**Council Request for further information in accordance with section 92 of the Resource Management Act 1991 in relation to lodged documents for: Notices of Requirement given by Auckland Transport for the Takaanini Level Crossing Project**

<p><b>Notices of Requirement:</b> given by Auckland Transport for the Takaanini Level Crossing Project, which is comprised of two Notices of Requirement:</p>	
<p><b>Notice of Requirement 1</b></p>	<p>The construction, operation, maintenance and upgrade of transport infrastructure on and around Spartan Road, Manuia Road, Manuroa Road and Taka Street which includes:</p> <ul style="list-style-type: none"> <li>• the closure of the existing level crossings at Spartan Road, Manuroa Road and Taka Street,</li> <li>• new bridges with general traffic lanes and walking and cycling facilities across the NIMT railway line at Manuia Road and Taka Street,</li> <li>• new bridges with walking and cycling facilities across the NIMT railway line at Spartan Road and Manuroa Road,</li> <li>• all associated works.</li> </ul>
<p><b>Notice of Requirement 2</b></p>	<p>The construction, operation, maintenance and upgrade of transport infrastructure within the Walters Road

### NoR 1 Manuia Road project area

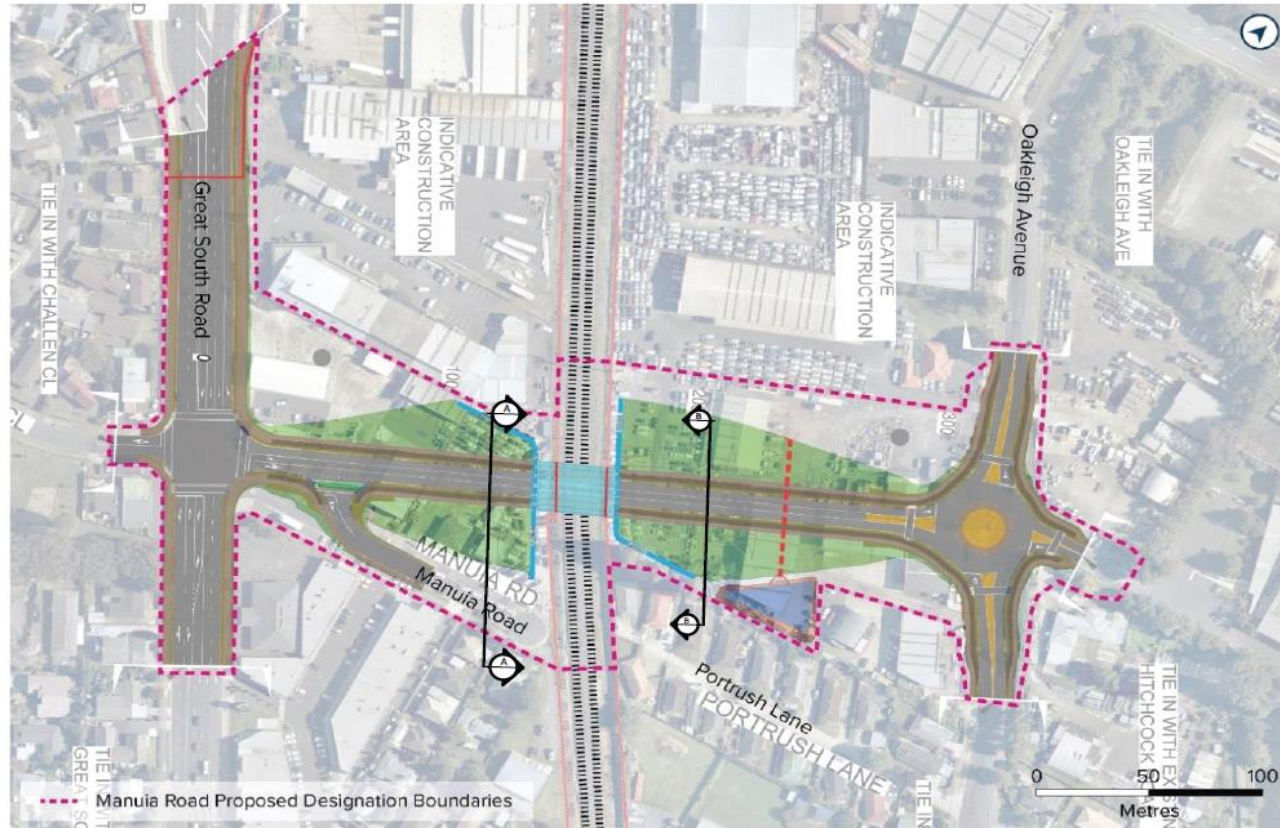
Issue identifier	Reference (Report name, section, page number)	Further Information Requested	Reasons for further information request
		arrangement is shown for future access of residual residential parcels.	
UD4	Urban Design Evaluation	Please confirm where access lanes to existing and future land parcels are illustrated that these are appropriately scaled and dimensioned to accommodate potential growth in line with PC 78/NPSUD objectives.	To determine in broad terms effectiveness of post construction integration and urban design outcomes.
UD6	Urban Design Evaluation	Please provide explanation of the vehicle turning provisions for 7-13 Taka St. Why is a turning head not required?	To determine in broad terms effectiveness of post construction integration and urban design outcomes.
